DATE: NOVEMBER 1987  
SHEET: 1 of 20  
BULLETIN: JD 10/87

## 18 ENGINE IDLE QUALITY

XJ6 3.6

FIG 1

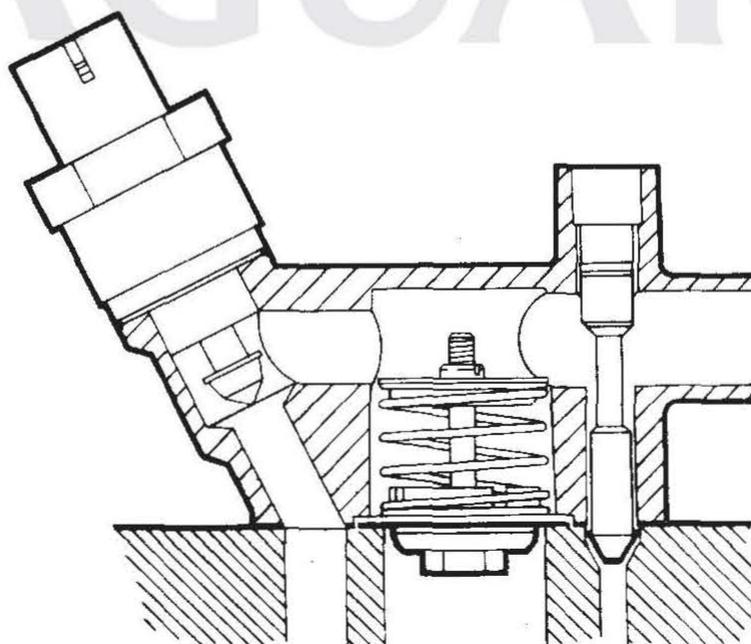
Reports have been received that following the replacement of the idle speed control valve, the engine base idle speed cannot be reduced to specification.

Should this problem be experienced, loosen the four idle speed control valve retaining screws and reposition the valve to ensure that the tapered end of the adjusting screw is centralised with the inlet manifold by-pass drilling (Fig 1).

Tighten the retaining screws and adjust the engine base idle speed using the JDS engine set-up procedure.

FIG 1

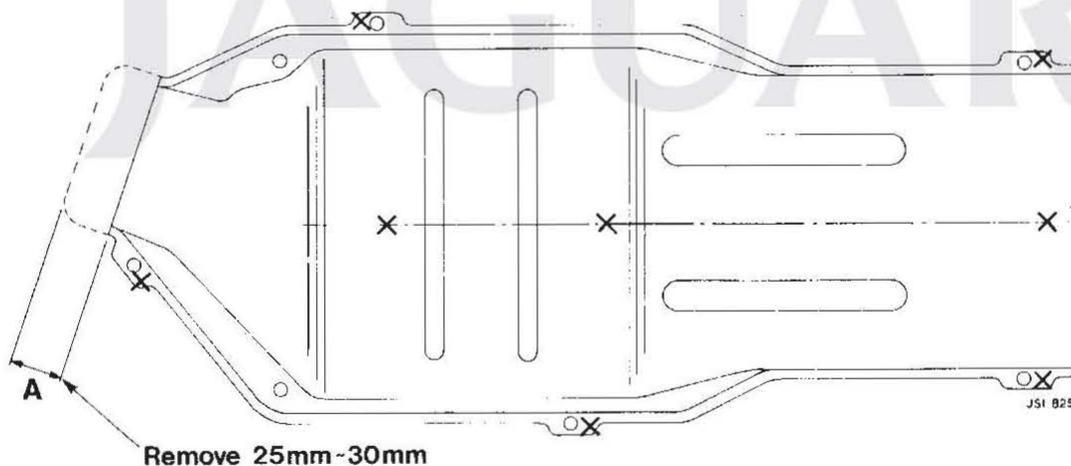
To overcome reports of catalyst heatshield rattle, a modified heatshield has been introduced on production from VIN 522802.

1. Remove the existing catalyst headshield.
2. Cut off the inlet nose (A Fig 1)
3. Cut off the same area from another stock heatshield Part No. CAC 8298/1 and fit one inside the other.
4. Spotweld (or bolt) the two heatshields together, see diagram for positions (X Fig 1).

5. Refit the modified heatshield assembly to the vehicle.

Fig 2

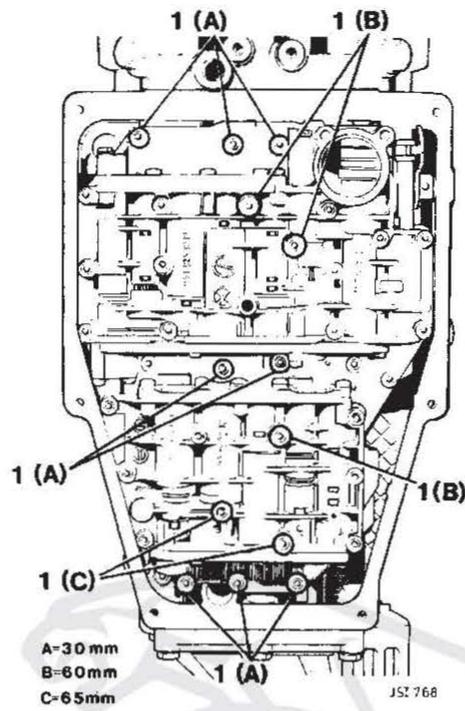
Where instances of this complaint are reported on **XJ6 3.6** models the valve block assembly can be replaced by a revised valve block, which is available as a serviceable item. This instruction does not apply to XJS 3.6 Models.

4. Remove the valve block assembly securing screws (1 Fig 2) and carefully lower the block.

NOTE: Only the large headed screws hold the assembly in position.

Note different length of screws (Fig 2).
